**Re:** **A-0004, Ghazi Boys High School Electrical Service**

**Dt:** 16 January 2010<<Date>>

Preliminary 1-Line Sketch

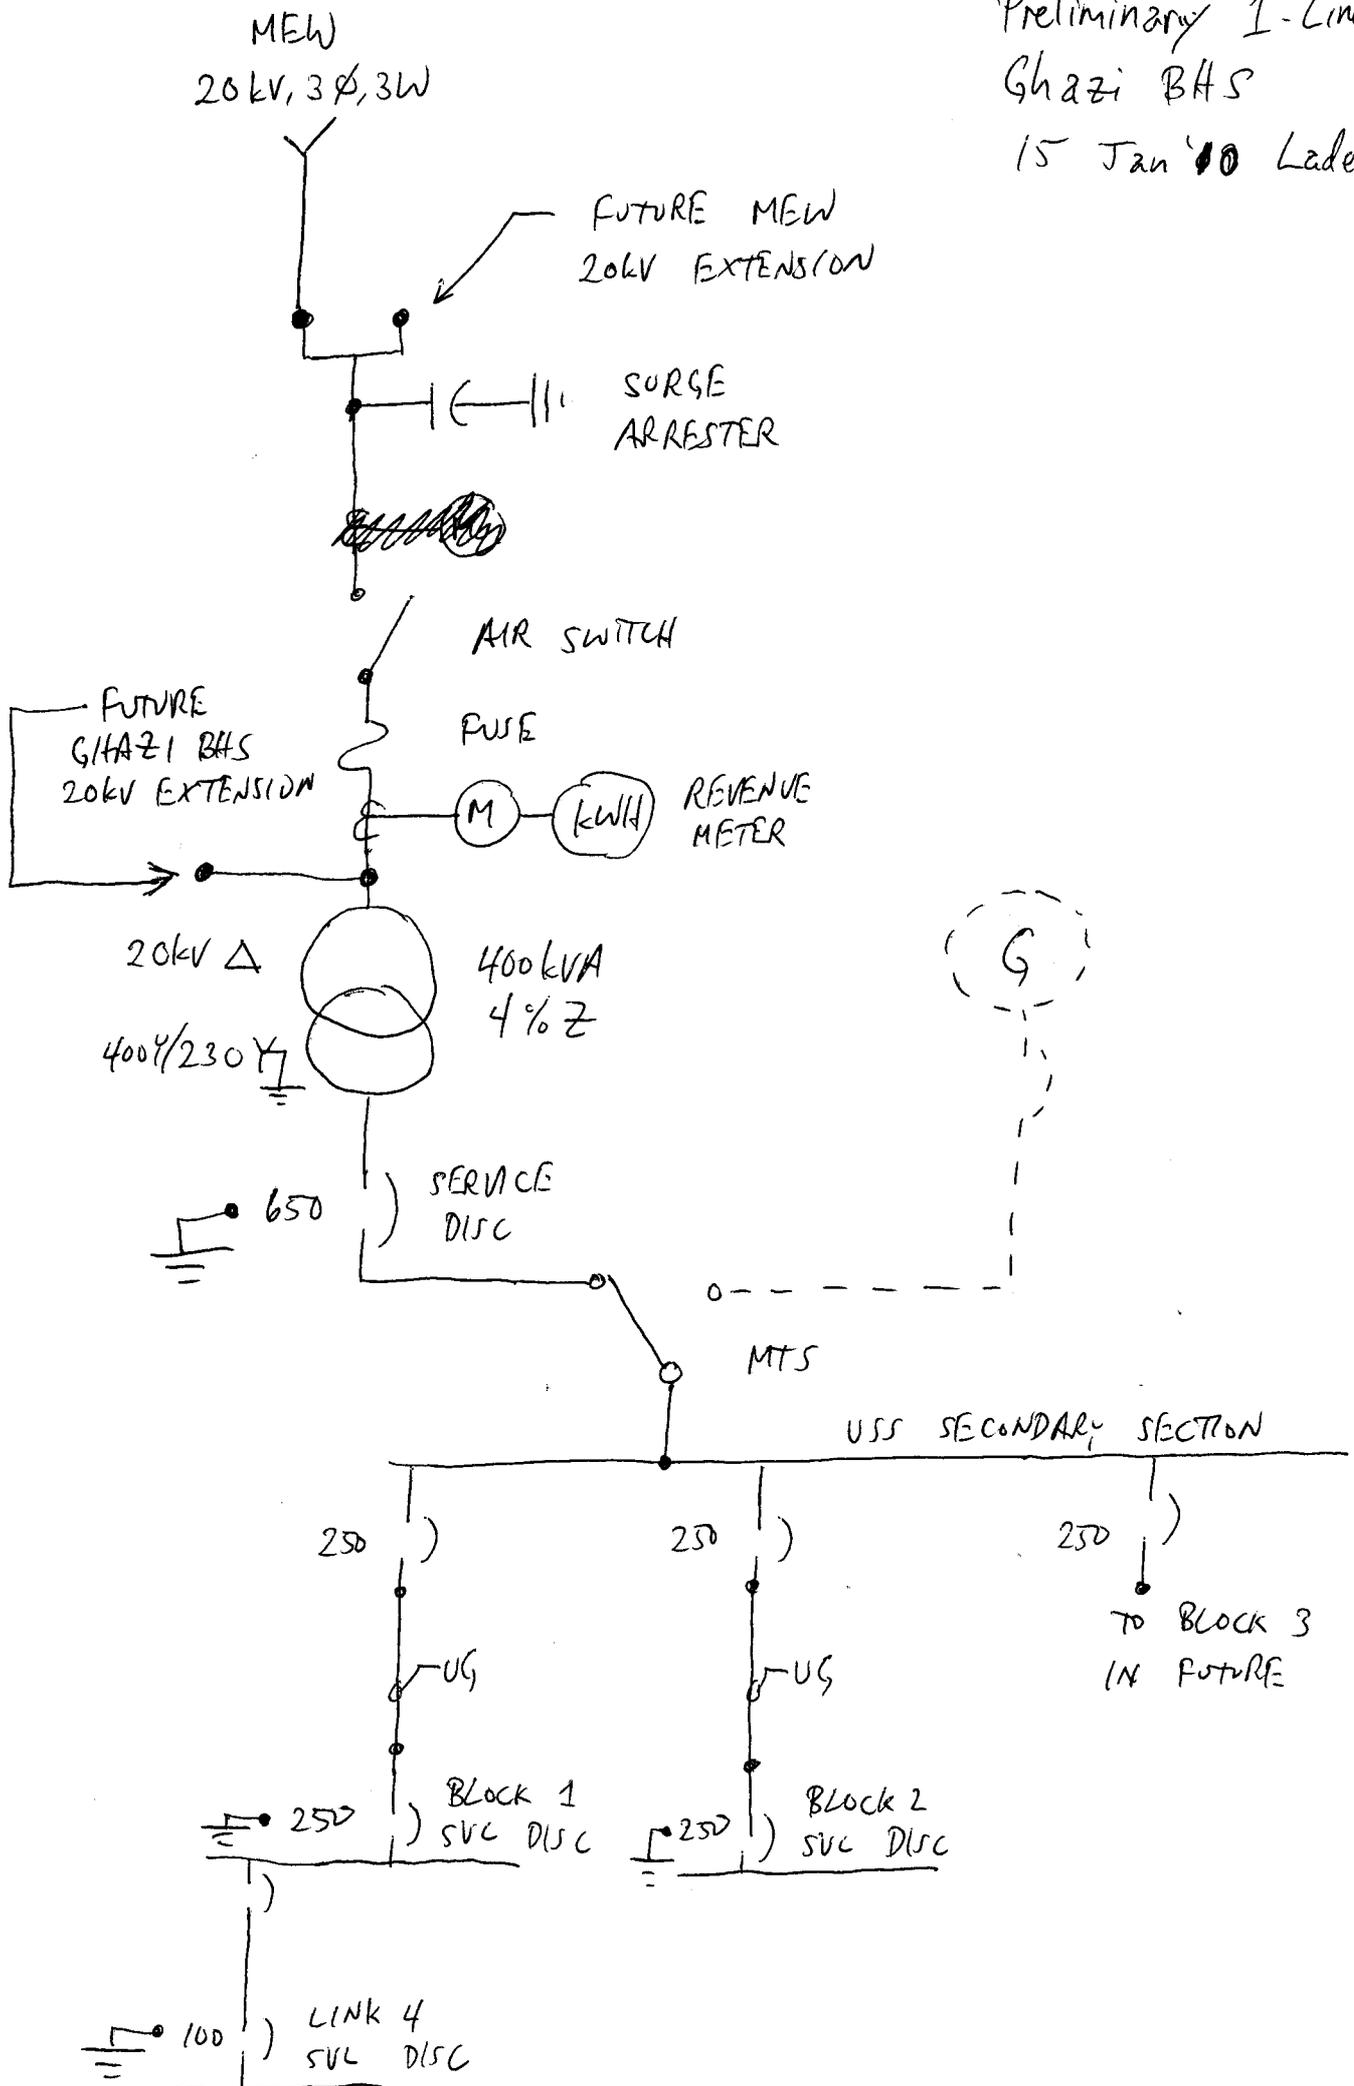
Secondary Unit Substation (USS): We propose furnishing and installing a Secondary USS at the terminus of the MEW 20-kV line with a primary surge arrester, primary air switch and metering chamber; a 400-kVA, 4%-Z, oil-filled, 20-kV delta primary to 400Y/230-V, 3-P, Wye secondary transformer; and a secondary distribution section with three (3) 200-A, 3-P, 20-kAIC circuit breakers. A preliminary one-line sketch of the USS is attached.

Standby power: Ghazi BHS may want to make provisions for a standby electric power system if the MEW supply proves to be unreliable. For now, a manual transfer switch would have to be supplied. It is shown in the one-line diagram. Space for a future standby diesel generator and diesel fuel tank should be reserved on the electrical site plan.

Preliminary Diagrammatic Sketch of the Site Power Routing

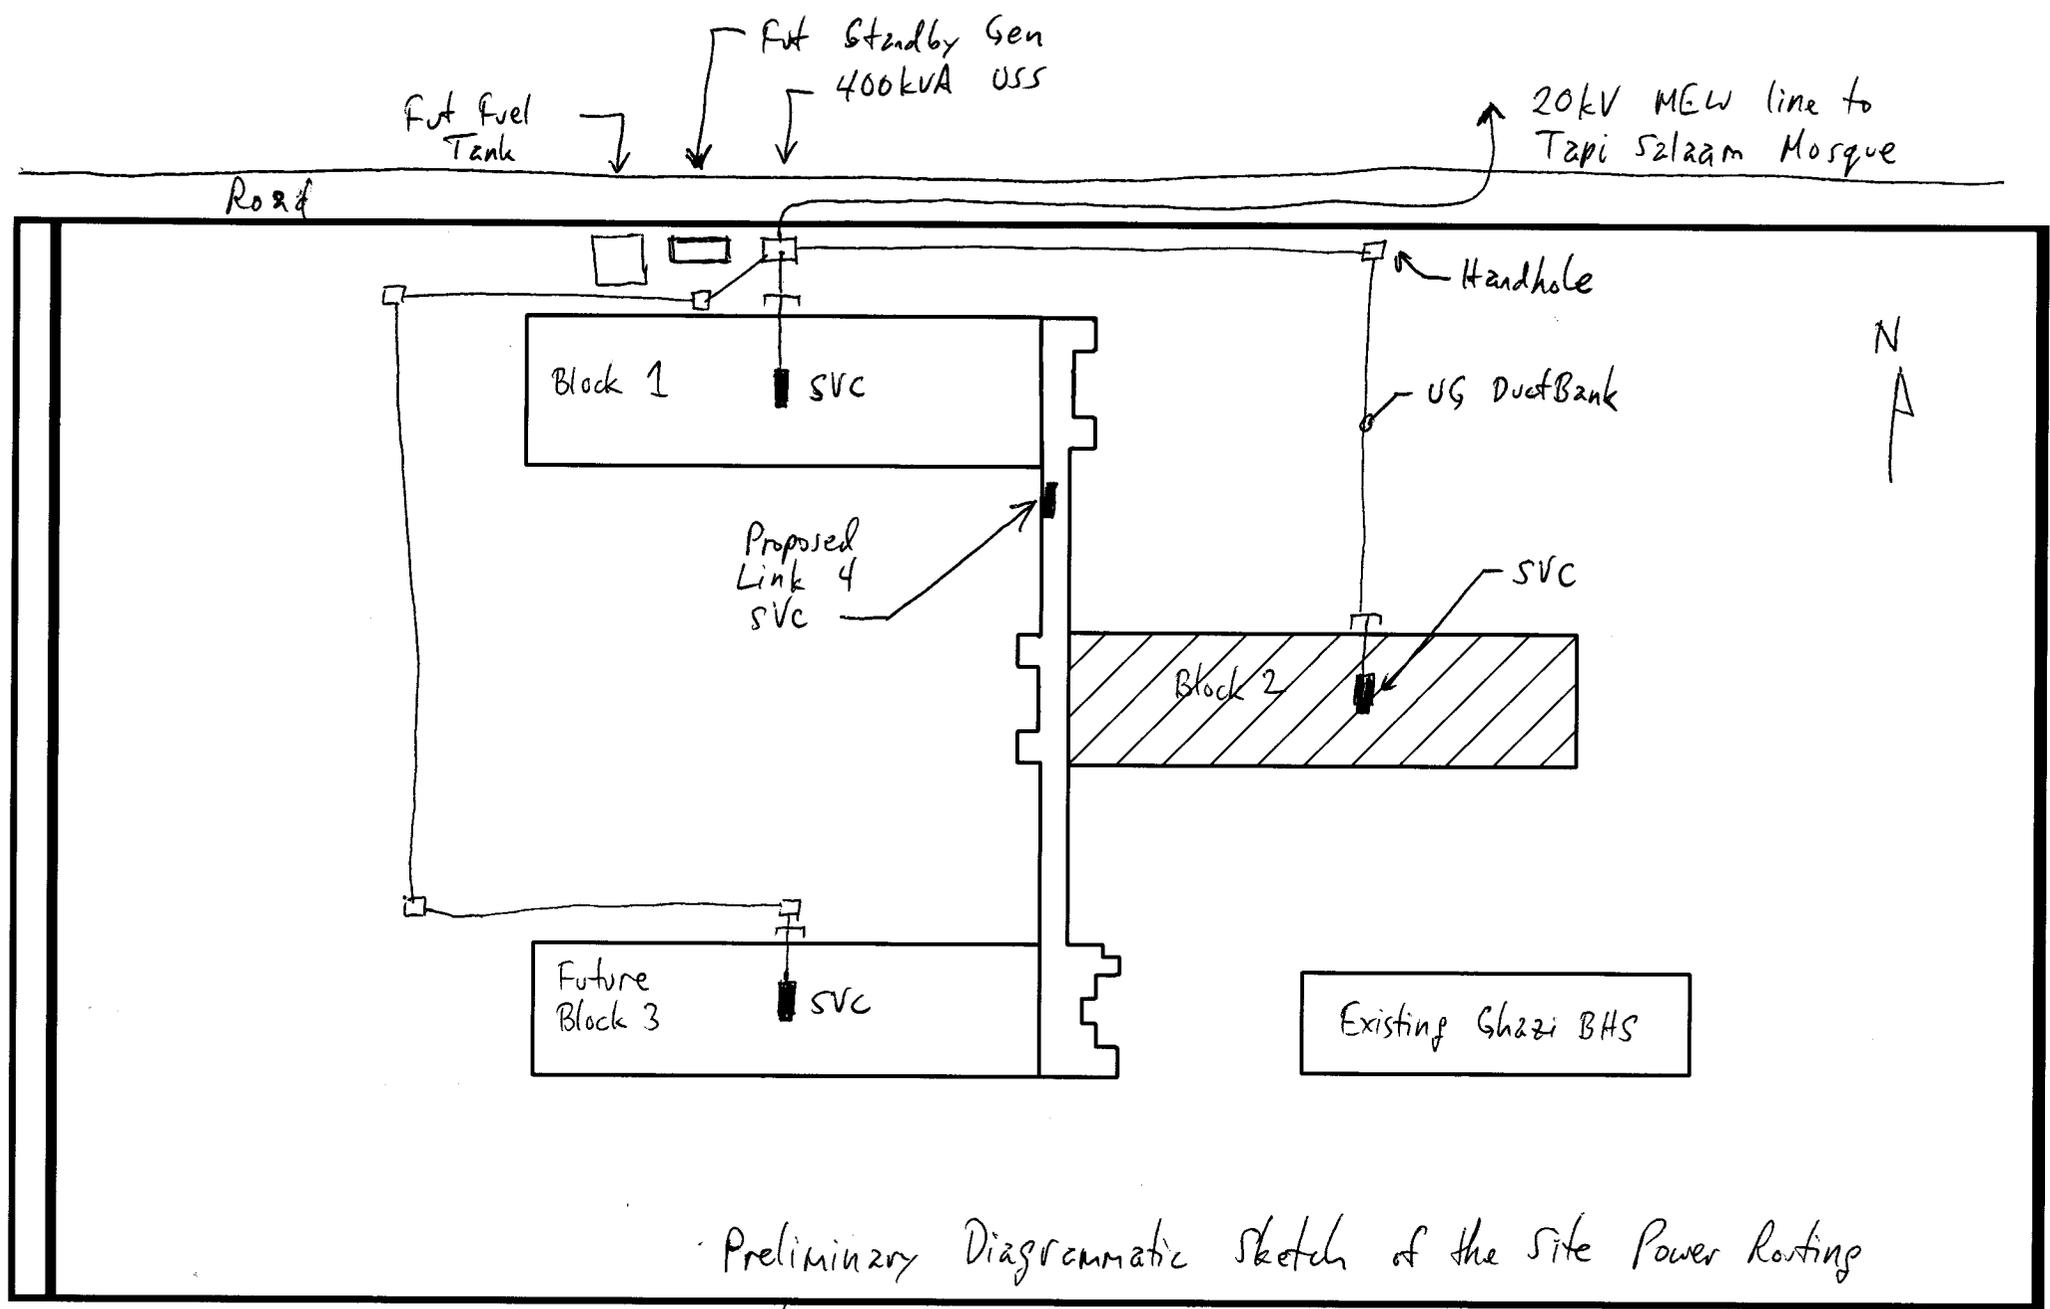
Site electrical work: The Secondary USS would be located on the electrical site plan. An underground direct buried duct for the service lateral from the Secondary USS directly south toward the Block 1 electric service stub out should be located. Another direct buried duct for the service lateral from the Secondary USS to Block 2 should be shown first headed directly east to a pulling hand-hole and then directly north to Block 2 electric service stub out. The route of the proposed third service lateral buried duct from the Secondary USS, around Block 1 and, eventually, through a series of hand-holes, to Block 3 should be shown. A preliminary diagrammatic sketch of the site power routing is attached.
